PLAN APPROVAL DOCUMENTATION

DRAWING REVISION HISTORY

SPA FABRICATION AUTHORIZATION

OXFORD SUITES

DWG TYPE SD

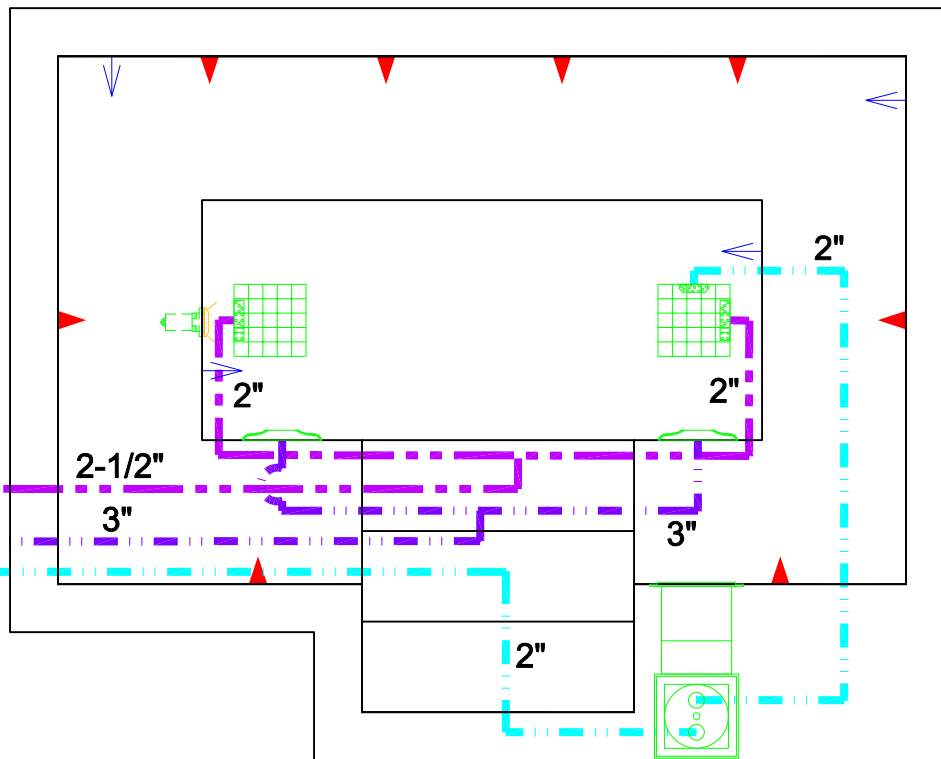
REV NOTE: 04-23 Changed Main Drain and Skid Configuration

REV NOTE: 05-02 Changed Spa Size & skid configuration

REV NOTE: 06-10 Moved Steps 2" Down

SIZE A	DWG NAME OXFORD SUITES	DWG TYPE PD Suction
SCALE 1/2" = 1'	DATE 6/10/2008	SHEET PAGE 3 OF 8

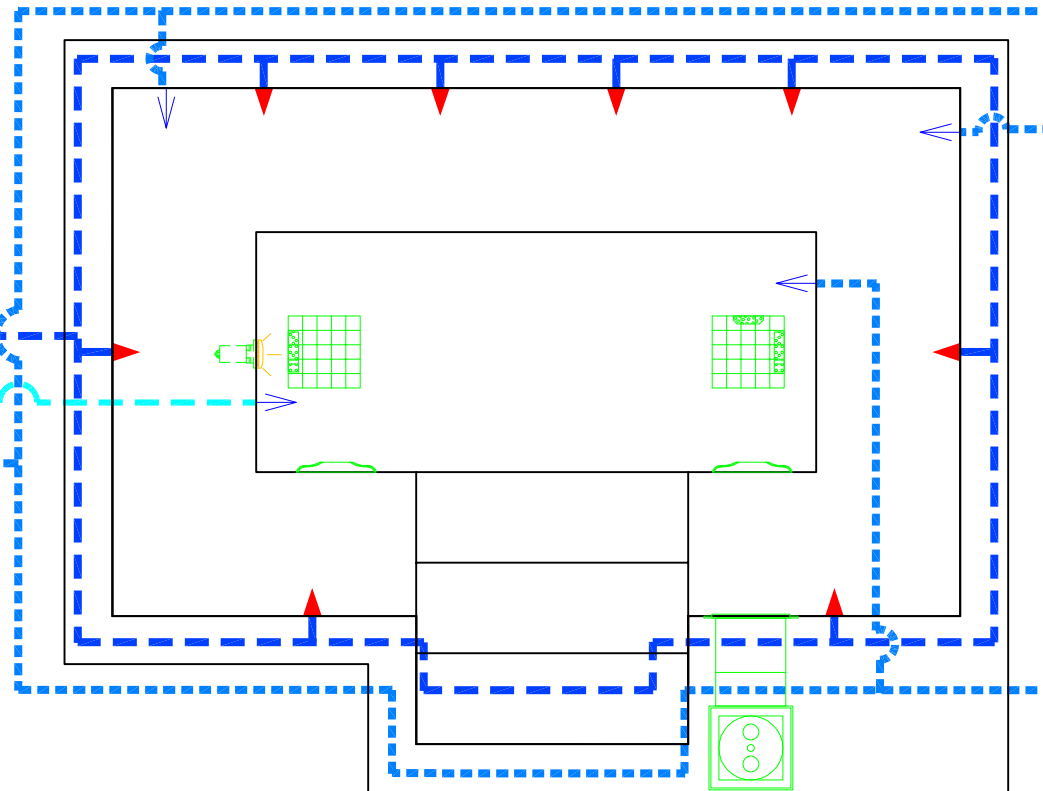
REV NOTE: 04-23 Changed Main Drain and Skid Configuration

REV NOTE: 06-10 Changed Drains and Suctions

PD Return

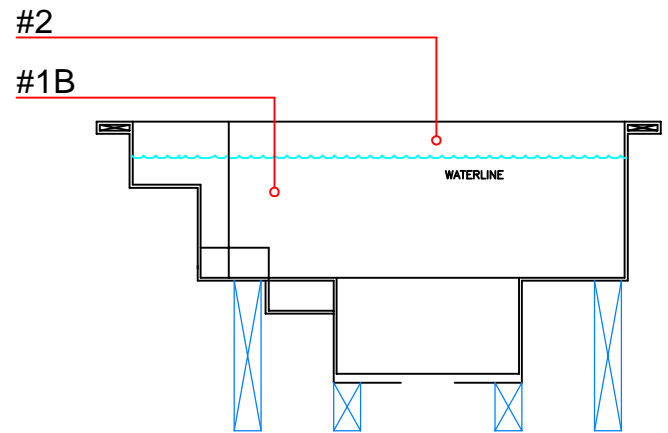
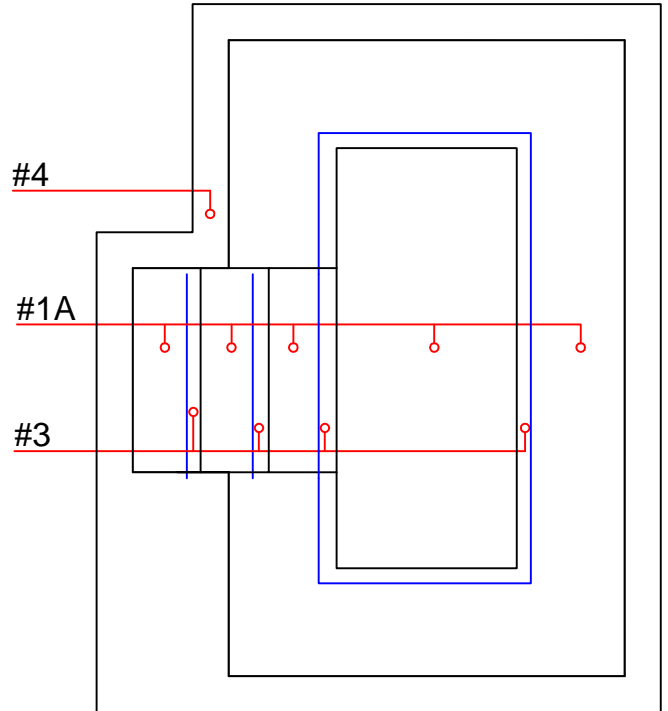
REV NOTE: 04-23 Changed Main Drain and Skid Configuration

TD Tile

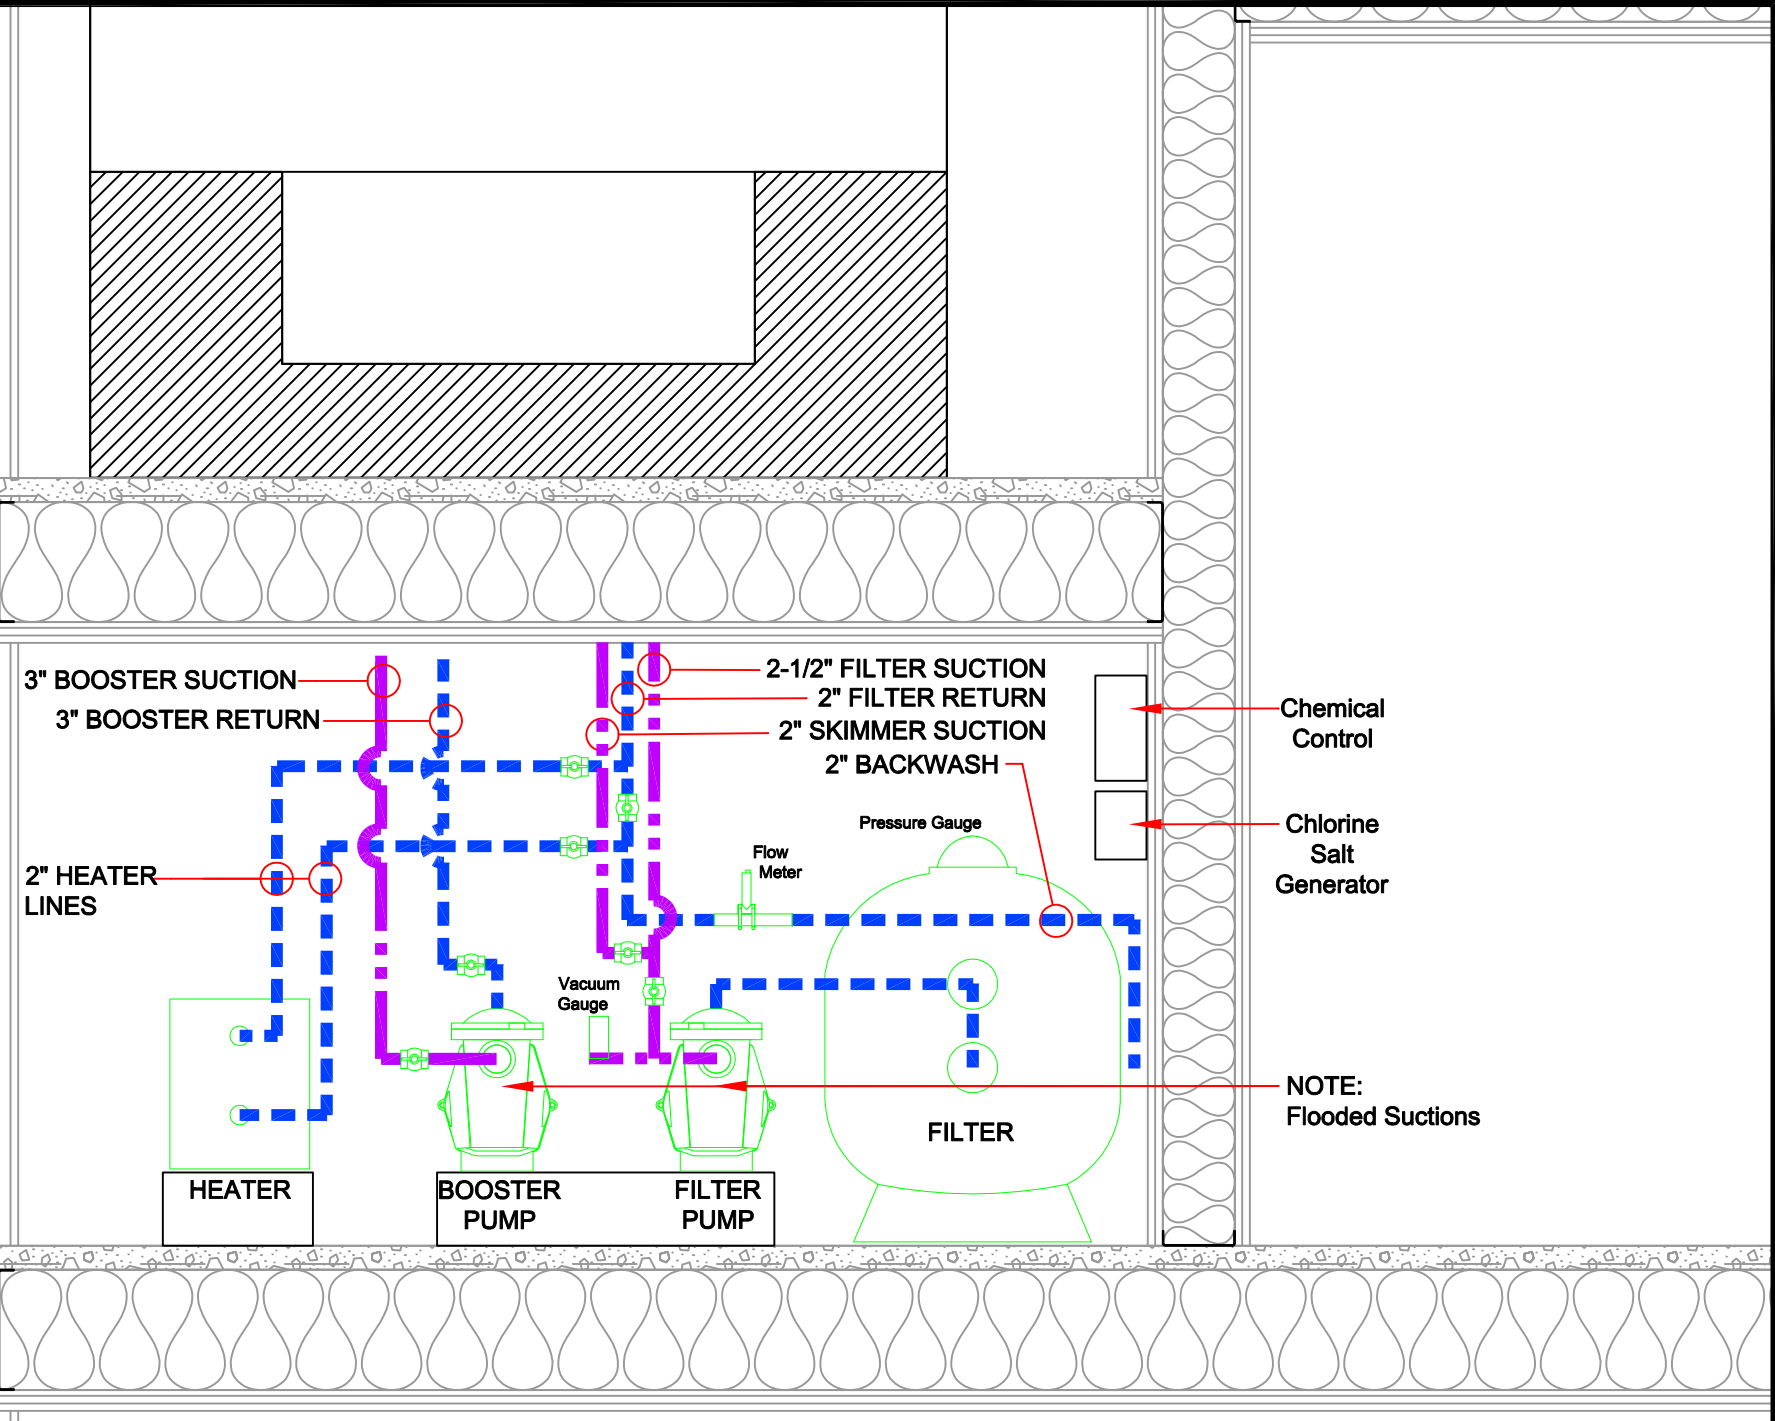
REV NOTE: 05-14 Added Tile Detail

REV NOTE: 06-10 Changed Tile Selection

REV NOTE: 06-24 Changed Tile Selection and grout
